LINCOLN PARK PLANNING COMMISSION

2017 Fort – Body Art Facility

Conceptual Site Plan Review

Applicant	Gary Gray, represented by Detroit Architectural Group
Project	Body Art Facility
Address	2017 Fort St. Lincoln Park, MI 48146
Date	October 13, 2021
Request	Conceptual Site Plan Review
Recommendation	None – Advisory Only

EXISTING SITE PLAN
 SCALE: 1:20 1

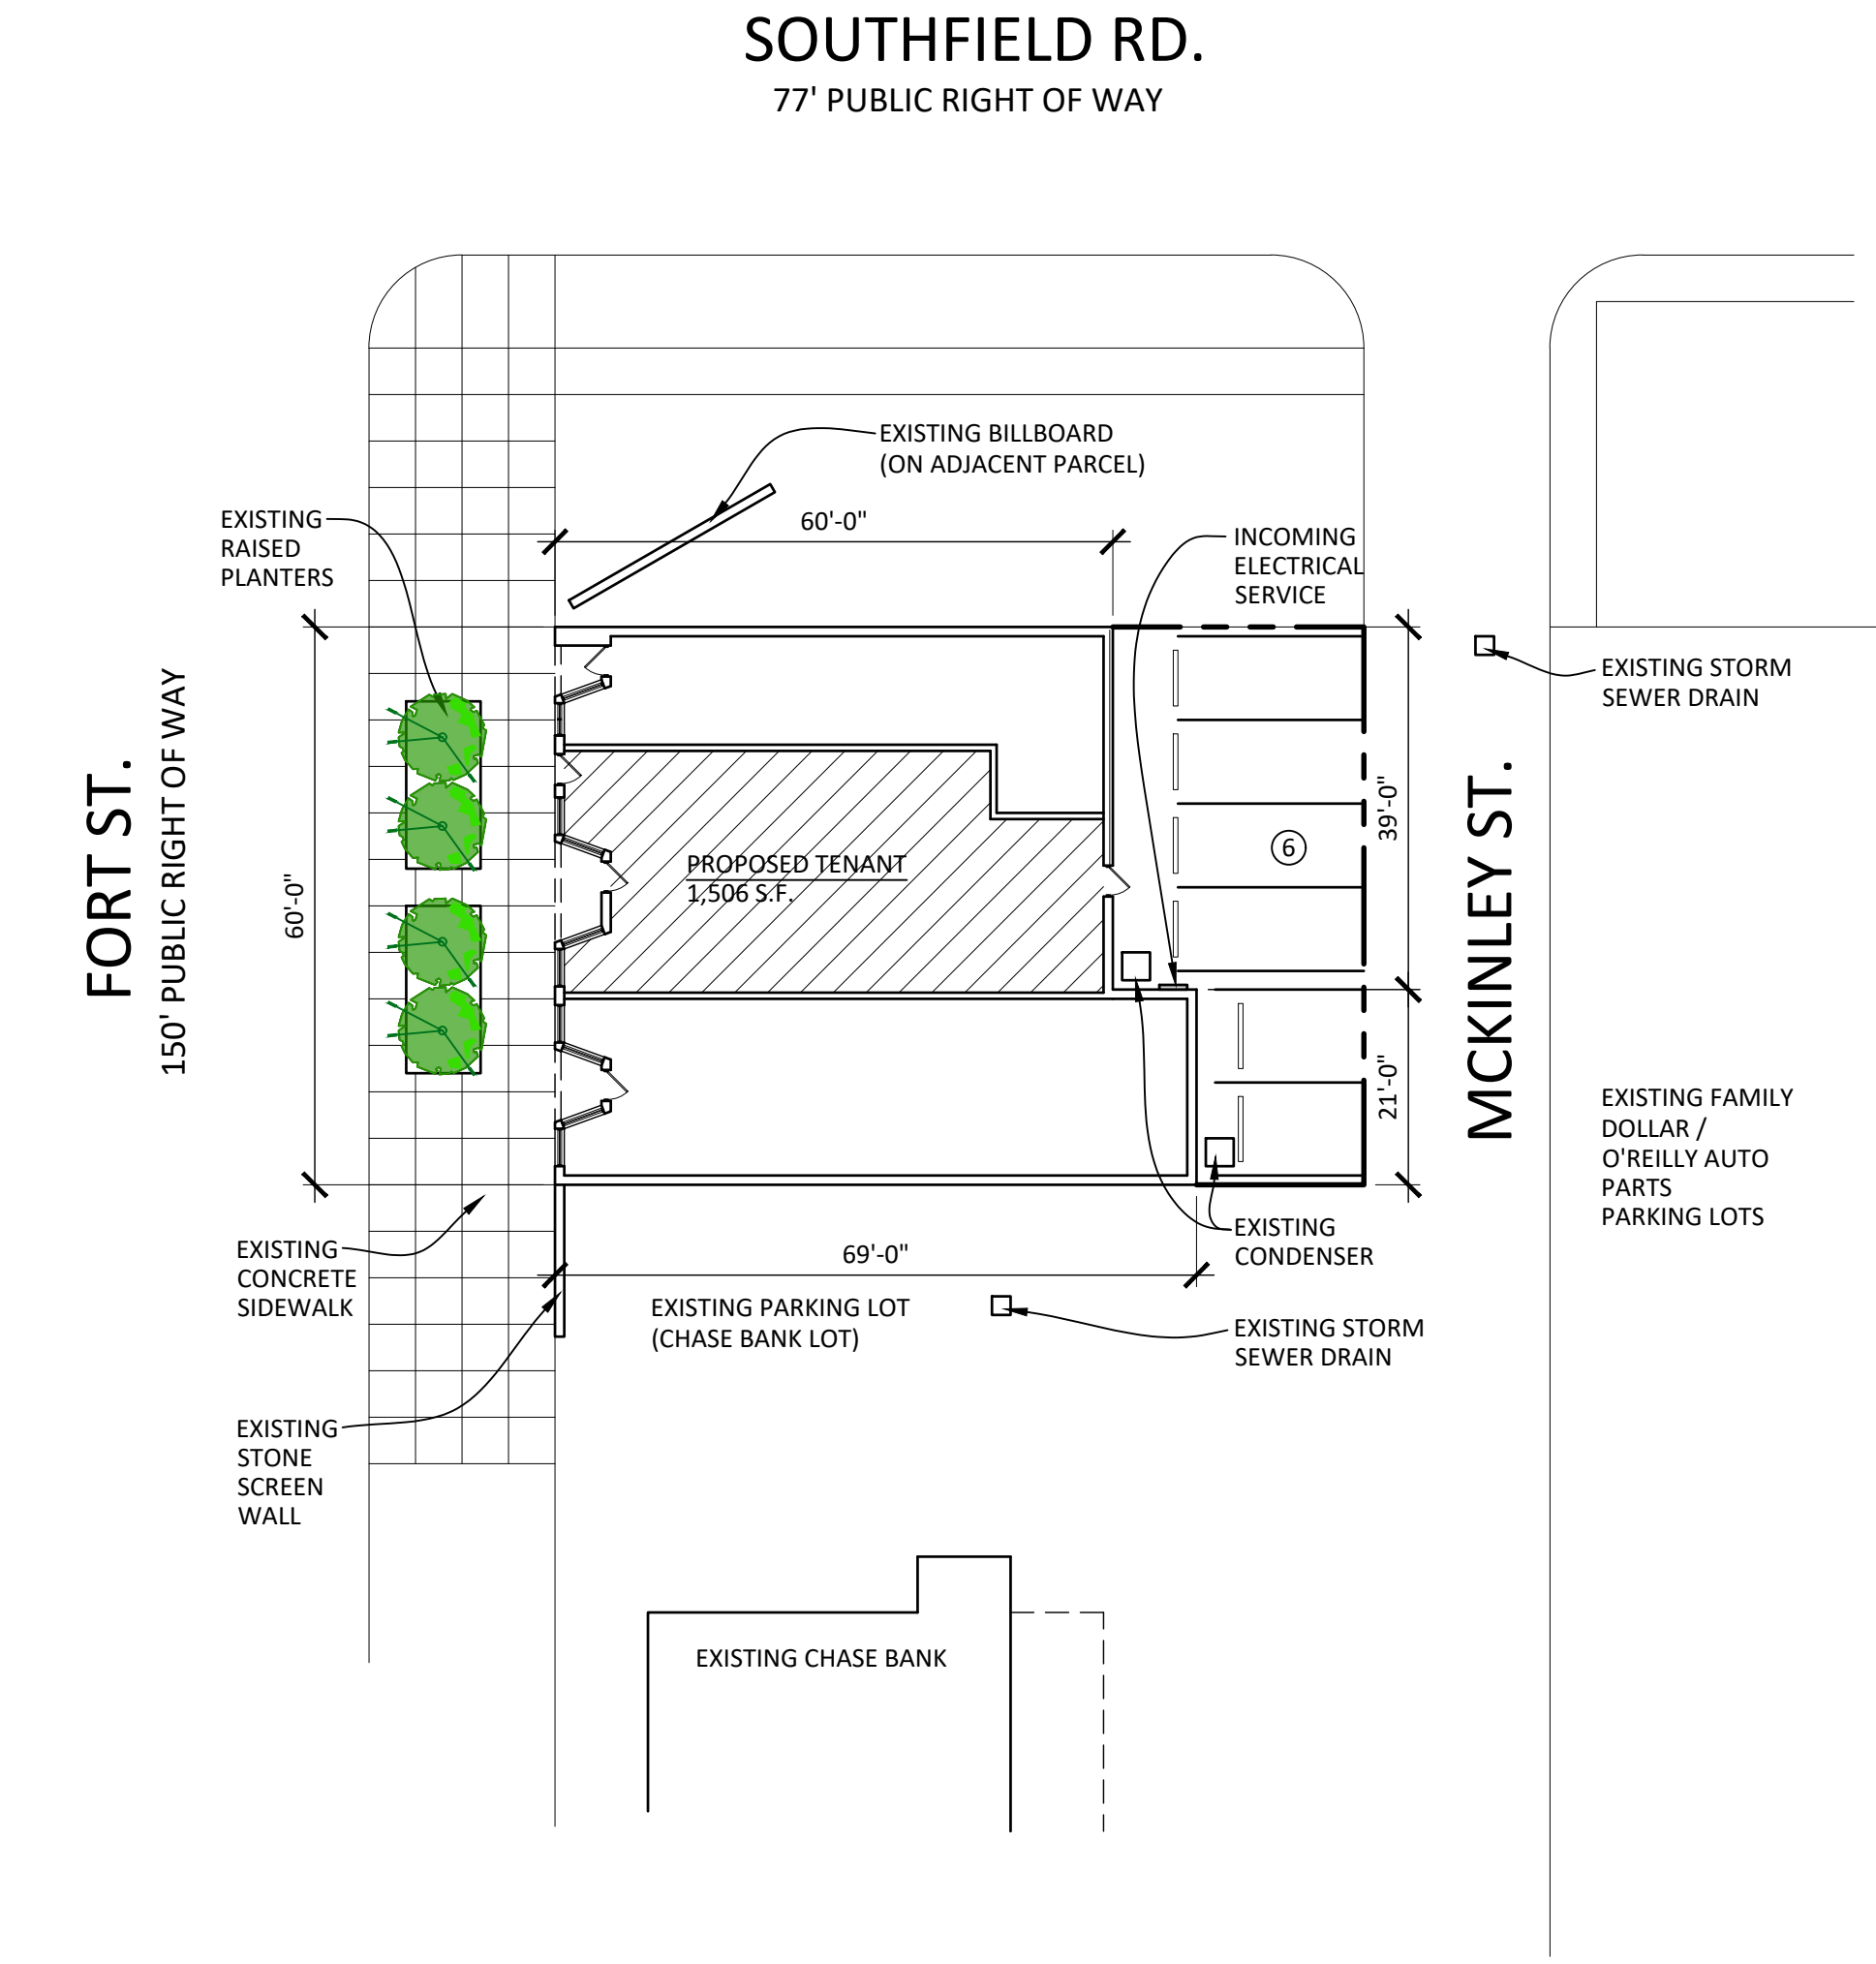
The allotted space for the two parking spaces is only about 20 feet wide, making the provision of a barrier-free space impossible with the dimension requirements for barrier-free parking spaces.

- *Applicant shall provide a trash management plan.*

The site is served by public water and sewer. No new water line or sanitary sewer systems are proposed for the site. Engineering comments state that if the existing sanitary sewer is going to be reused, the architect should verify that the existing sanitary service is adequate to handle the required flows for the building's use. If it is being reused, it is important that the developer realize this existing sanitary service is old and may have reached its life expectancy. It is highly recommended that the existing sanitary sewer service be videotaped to determine the condition of the service lead. If the existing water service is being reused, it is important that the developer realize this existing water service is also old and may have reached its life expectancy. If the existing service is a lead-type service or undersized, it will be required to be removed and replaced. The design professional must verify the existing water service type, size, and lead capacity and should verify that the existing service is adequate to handle the required flows. Utility connections should be shown on the plans.

There is existing ground-mounted mechanical equipment that is not screened. Should the existing equipment be replaced, it would need to be screened in accordance with Ordinance requirements.

- *Applicant shall work with the City Engineer to verify the existing water service and sanitary service type, size, and determine the lead capacity for the proposed building use.*
- *It is highly recommended that the existing sanitary service be videotaped to determine the condition of the service lead.*
